Planning and Zoning Commission

March 15, 2023 – REGULAR MEETING

Meeting Date:	March 15, 2023	Meeting Title:	Planning Commission
Submitting Department:	Planning Department	Presenter:	Paul Anthony
Agenda Item:	P23-015: Amendment to PUD Snake River Canyon Ranch (Teton County)	Public Comment:	Yes

Subject: PUD2022-0003 & AMD2022-0006: Amendment to Snake River Canyon Ranch Resort Master Plan and Teton County LDRs

Figure 7:
Proposed Phase II
Development and
Vegetative Cover

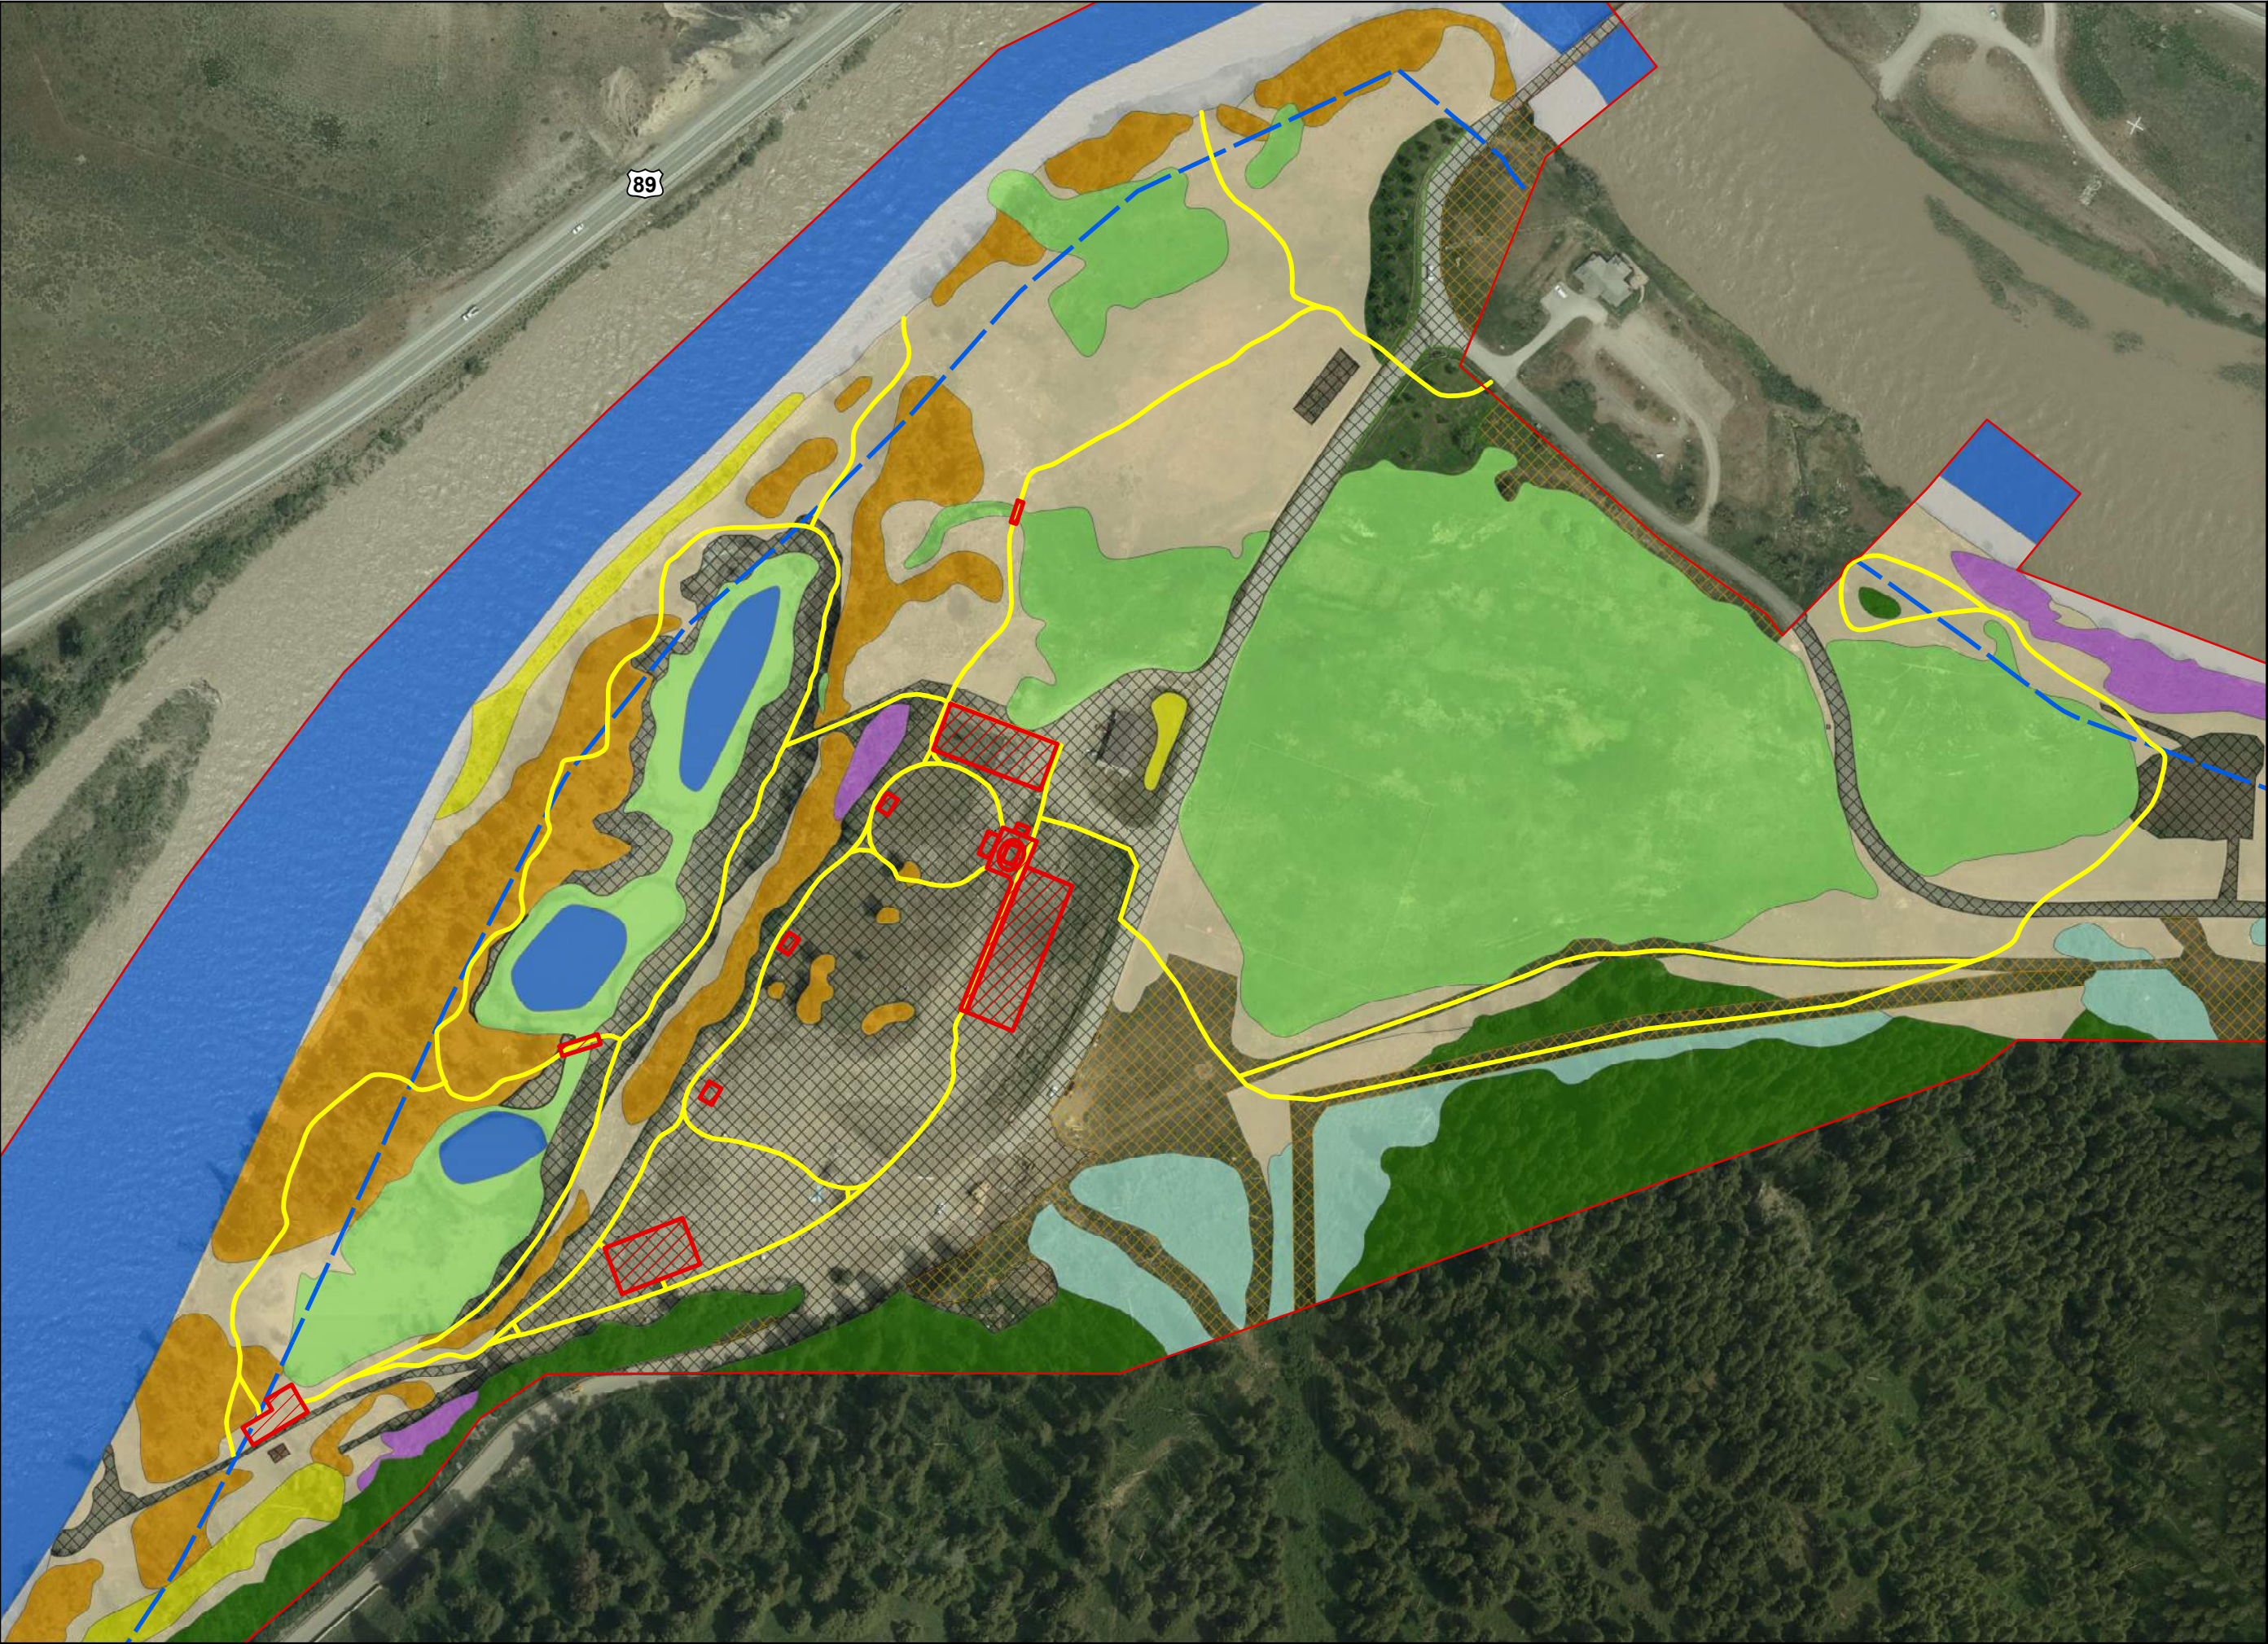
1. Figure 6 depicts the Community Programming Facility within the Snake River 150-foot protected waterbody setback. As presented in Figure 7 of the application in relation to the Snake River protected waterbody setback, the proposed Community Programming Facility does not comply with the LDRs. No development, including the construction limits of disturbance, shall occur within the Snake River setback, that is not found to be compliant with Sections 5.1.1D.2 and 5.1.1D.3.a of the LDRs.

Figure 6:
Proposed Building
Envelope and Vegetative
Cover Types

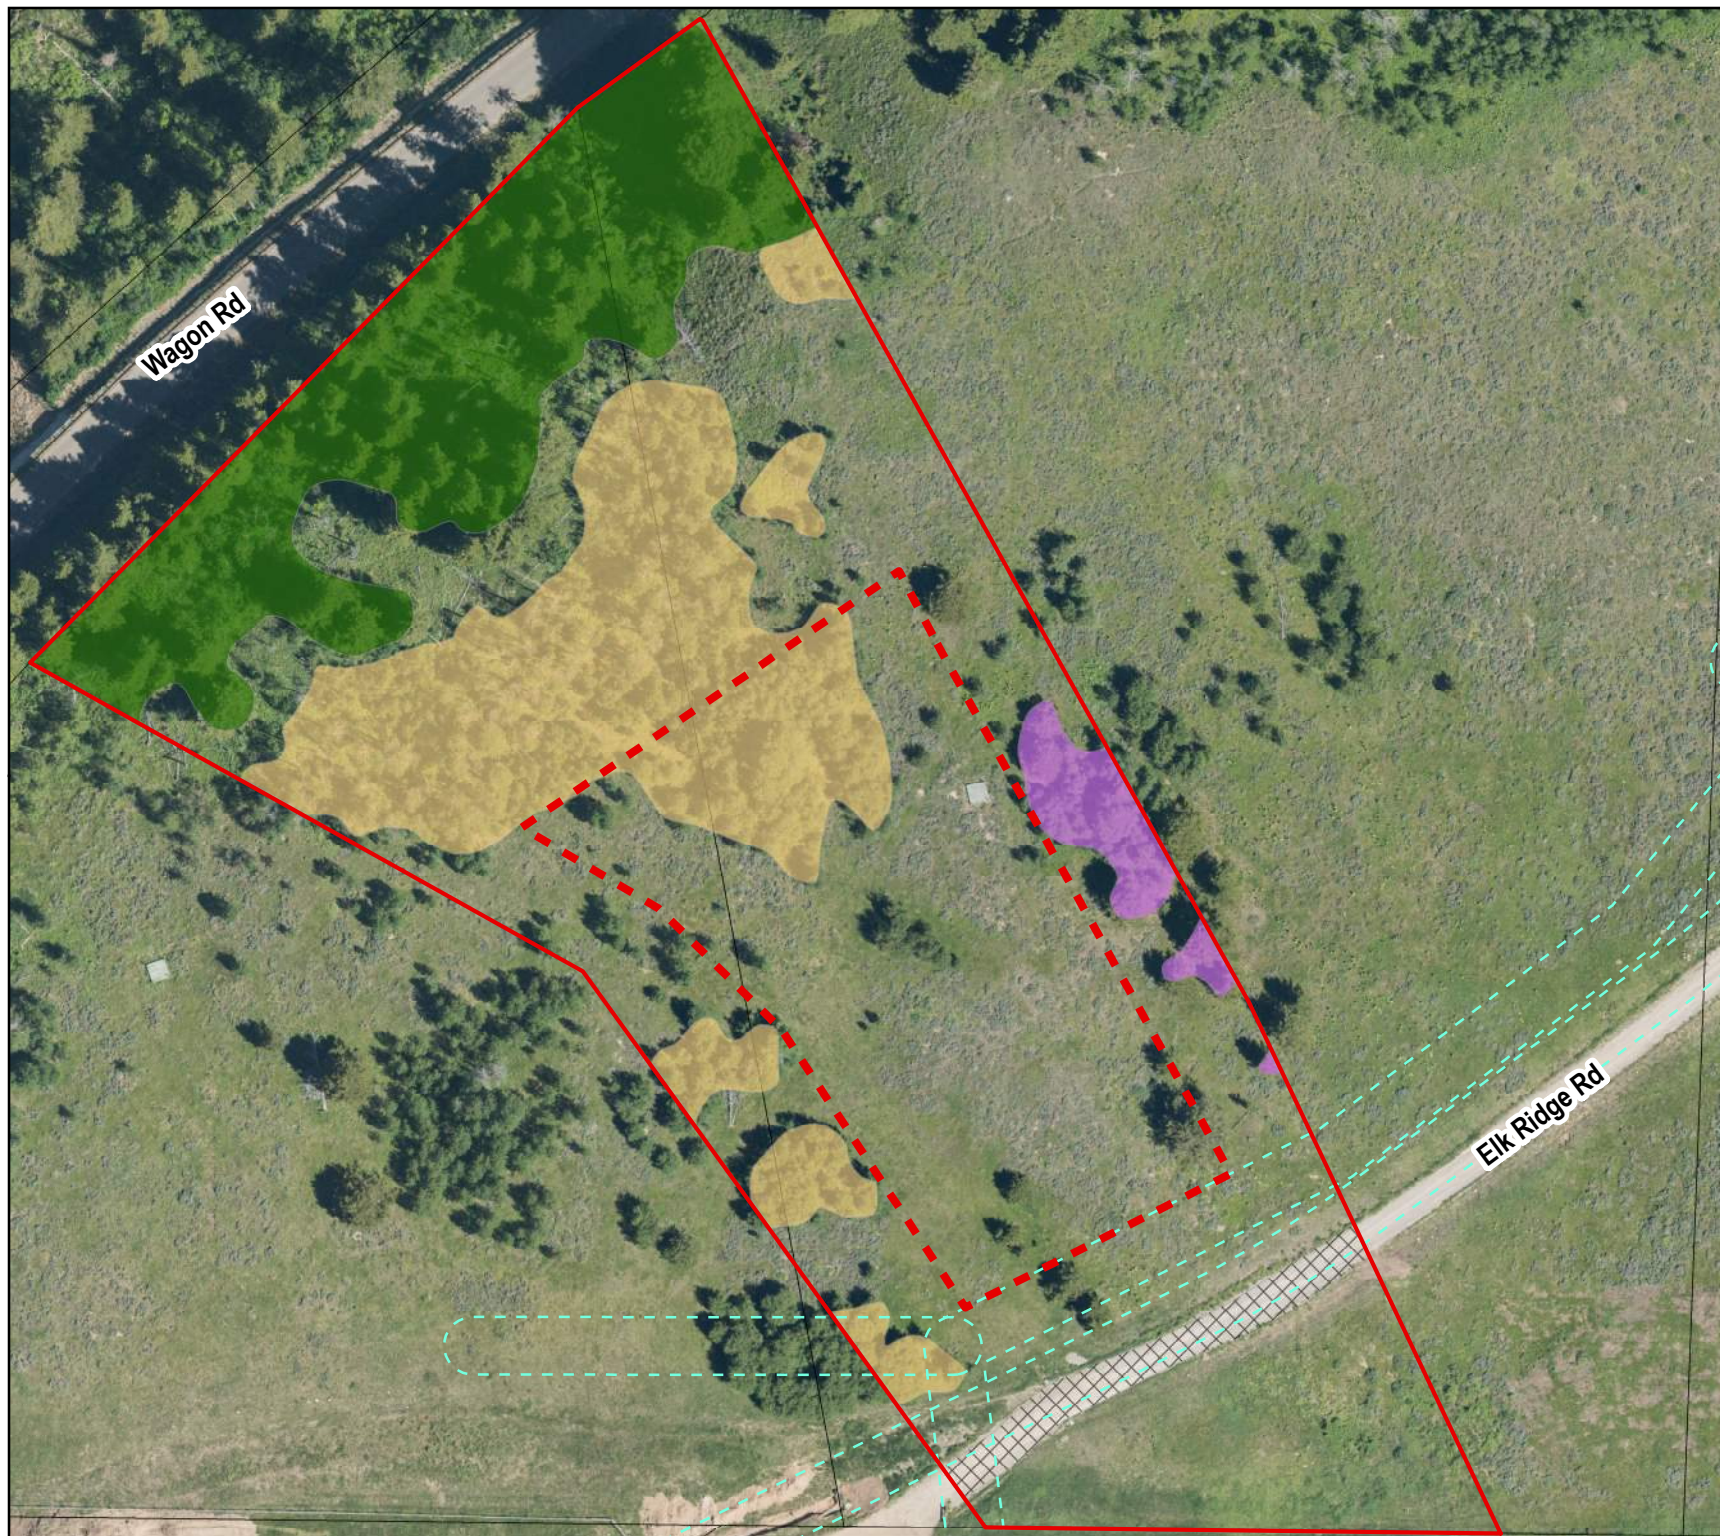
Based upon the review of the access and development area submitted with this EA, and in accord with Division 5.1 and 5.2 of the LDRs, the Planning Director recommends that the updated building envelope/development area, as described in EA Figure 6 dated March 14, 2022, is acceptable with the following seven (7) conditions:
